**PLANNING APPROVAL,
PLANNED UNIT DEVELOPMENT &
SUBDIVISION STAFF REPORT****Date: November 20, 2014**

<u>NAME</u>	Ladd-Peebles Stadium
<u>SUBDIVISION NAME</u>	Ladd-Peebles Stadium Subdivision
<u>LOCATION</u>	1621 Virginia Street (Southeast corner of Virginia Street and Lott Street, extending to the North side of Dublin Street East)
<u>CITY COUNCIL DISTRICT</u>	District 2
<u>PRESENT ZONING</u>	B-3, Community Business District.
<u>AREA OF PROPERTY</u>	2 Lots / 43.1± Acres
<u>CONTEMPLATED USE</u>	Planning Approval to allow a cell tower in a B-3, Community Business District; Planned Unit Development approval to allow shared access between two building sites; and Subdivision approval to create two legal lots of record from an existing metes-and-bounds parcel.
<u>TIME SCHEDULE FOR DEVELOPMENT</u>	None given.
<u>ENGINEERING COMMENTS</u>	Subdivision: The following comments should be addressed prior to submitting the FINAL PLAT for acceptance and signature by the City Engineer: <ul style="list-style-type: none">A. Provide all of the required information on the SUBDIVISION PLAT (i.e. signature blocks, signatures, certification statements, written legal description, required notes, legend, s

SITE PLAN

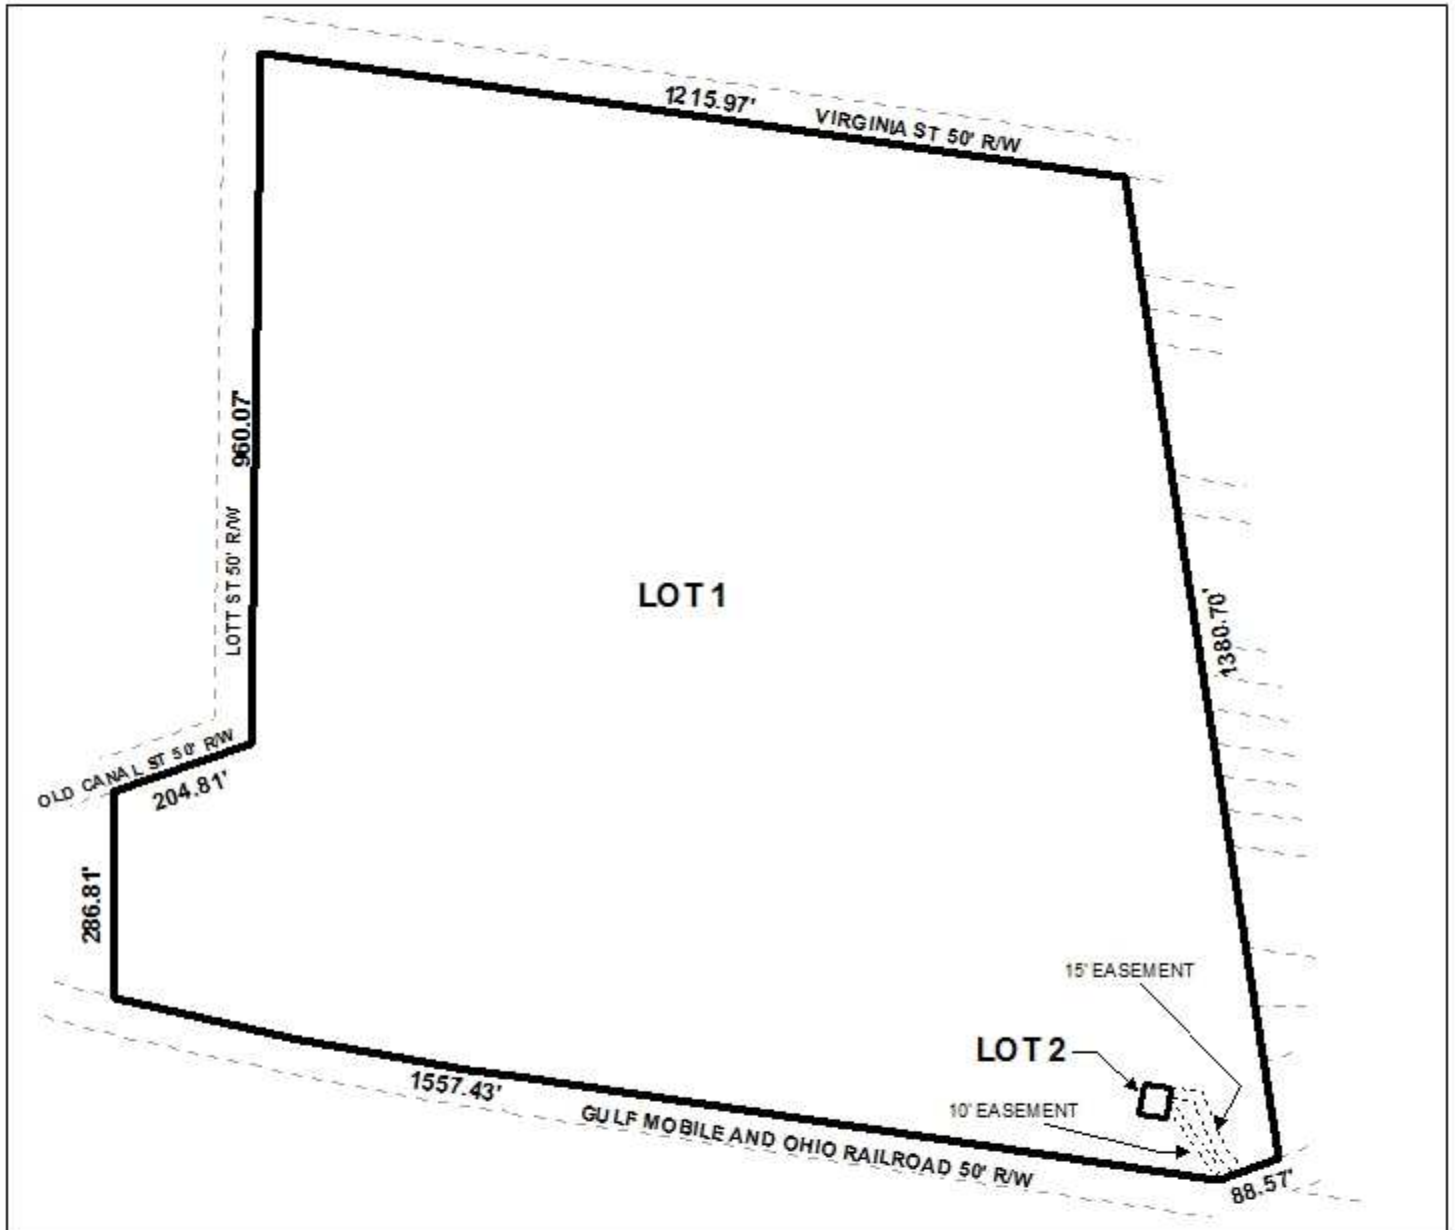
The site plan indicates the tower compound to be just to the interior of the stadium paved drives at the Southeast corner of the property near the Dublin Street East entrance. The tower compound would be completely surrounded by the parking, access, and detention facilities associated with Ladd-Peebles Stadium. As the tower lease parcel is proposed to be a separate legal lot of record and land-locked, its access would be across the stadium property; therefore, the PUD is needed for the shared access. Access from the paved stadium drive to the tower compound is proposed to be via a 12' wide gravel drive and parking space, for which a Surface Variance is requested. An 8' high wooden privacy fence is proposed around the tower compound. The site plan does not indicate any tree plantings around the compound. Due to the fact that gravel access and parking are indicated and no tree plantings are indicated, should the Surface and Tree Planting Variance requests be denied by the Board of Zoning Adjustment, the site plan should be revised to indicate compliant access and parking surfaces and compliant tree plantings.

The plat should be revised to label Lot 1 with its size in both square feet and acres, or a table should be furnished on the Final Plat providing the same information.

The plat should be revised to illustrate a 25' minimum building setback line along all street frontages except Virginia Street. A 40' minimum building setback line should be illustrated along Virginia Street to account for any future widening in compliance with the Major Street Plan.

It should be noted that the preliminary plat provided is reduced below the given scale of 1"=100'; therefore, the Final Plat should be revised to scale as given on the plat. Also, the plat includes a signature block for the City Clerk. As that office does not sign subdivision plats, that signature block should be removed from the Final Plat. The plat should, however, be revised to add a Traffic Engineer's signature block.

- 1) revision of the plat to label both lots with their sizes in both square feet and acres, or the furnishing of a table on the Final Plat providing the same information;
- 2) placement of a note on the Final Plat stating that Lot 2 is limited to the existing curb cuts to all streets, with the size, location and design of all curb cuts to be approved by Traffic Engineering and conform to AASHTO standards;
- 3) revision of the plat to illustrate a 25' minimum building setback line along all street frontages, except Virginia Street;
- 4) revision of the plat to illustrate a 40' minimum building setback line along Virginia Street;
- 5) revision of the plat to coincide with the scale as given on the plat;
- 6) removal of the City Clerk signature block on the Final Plat;
- 7) revision of the plat to include a signature block for the City Traffic Engineer;

DETAIL SITE PLAN

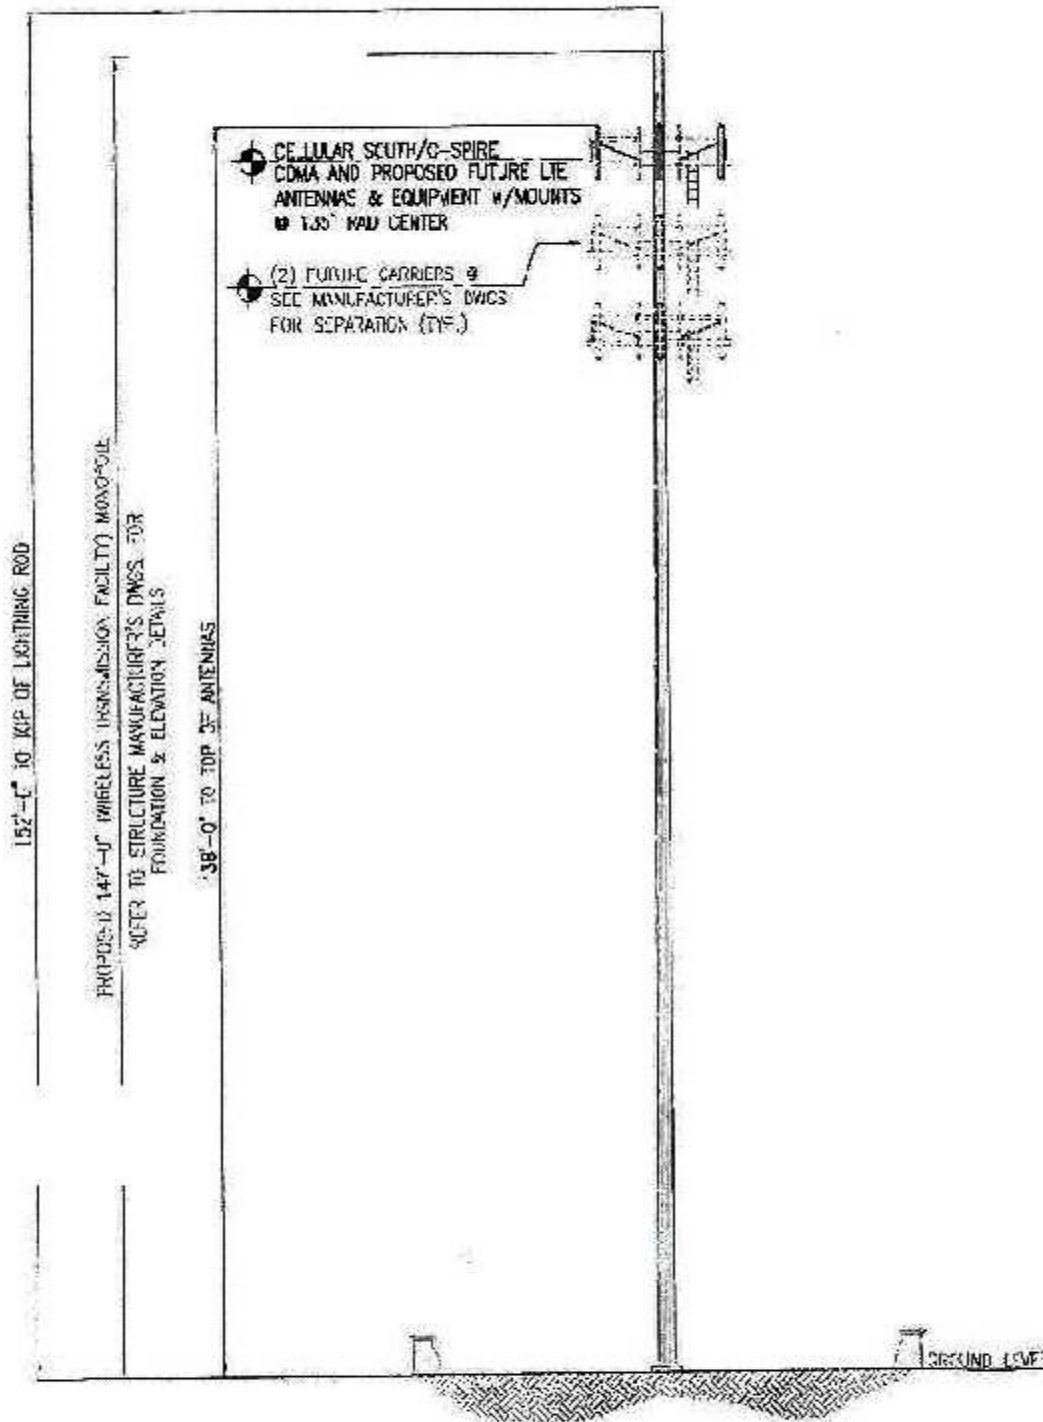
Discrepancies existed in the initial submission of the Planning Approval application in that the cover letter indicated a tower structure height of 140' with a 10' lightening rod above, bringing the overall height to 150' above ground level, and the tower elevation drawing indicated the tower structure to be 147' high with no lightening rod above. The antennae were illustrated as extending slightly above the tower structure. The cover letter and tower elevation drawing have been revised to indicate the tower structure height to be 147' above ground level (AGL) with a 5' lightning rod above, bringing the entire tower and appurtenances to a height of 152' AGL. The top of the antennae are now illustrated as being at a height of 138' AGL.

- 1) the tower limited to a monopole design, 147' high, with a 5' lightning rod above, with an overall height of 152' above ground level;
- 2) revision of the site plan to indicate a compliant vehicular access and parking surface outside the tower compound should the Surface Variance request be denied by the Board of Zoning Adjustment;
- 3) revision of the site plan to indicate compliant tree plantings, if required, around the tower compound, to be coordinated with the Planning Division of the urban Development
